APPLICATION NO.	FILING DATE	FIRST NAMED INVENTOR	ATTORNEY DOCKET NO.	CONFIRMATION NO.
10/538,508	01/06/2006	Andrew Charlton Clothier	424662011500	1875
	7590 01/24/200 E FOERSTER LLP	EXAMINER		
	BOULEVARD		RO, BENTSU	
SUITE 300 MCLEAN, VA	22102		ART UNIT	PAPER NUMBER
			2837	
, SHORTENED STATUTOR	Y PERIOD OF RESPONSE	MAIL DATE	DELIVERY MODE	
3 MONTHS		01/24/2007	PAPER

FINAL REJECTION

[insert drawing #3]

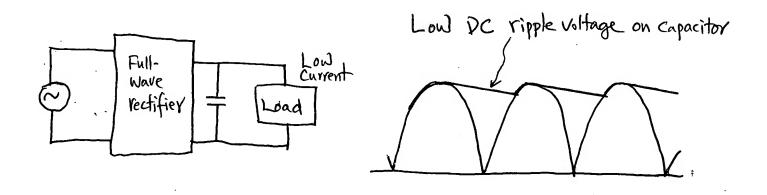
The following circuit and waveform show a full-wave rectifier with a smoothing capacitor and with a low current load.

[insert drawing #4]

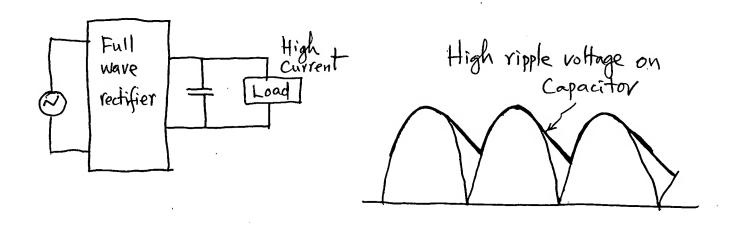
The following circuit and waveform show a full-wave rectifier with a smoothing capacitor and with a high current load.

Explanation and interpretation of claim ${\bf 1}$ with drawing showing the details.

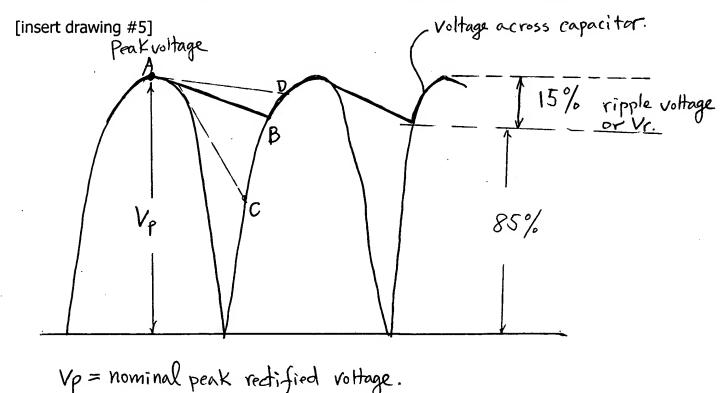
Points:

A ---- the nominal peak rectified voltage;

B ---- exactly below 15% of the peak voltage;

C ---- falls below 15% of the peak voltage;

D ---- falls above the 15% point.

Because claim 1 calls for <u>"the voltage across the capacitor **falls below 15%** of the nominal peak rectified voltage of the source during each cycle of the alternating <u>source."</u> (Emphasis added.).</u>

Point D cannot be "falls below 15%", only point C can because the peak voltage is at point A, and 15% below A is B. Fall below 15% should be any points below point B, that is point C, not point D. Therefore, the examiner's interpretation is accurate and correct.
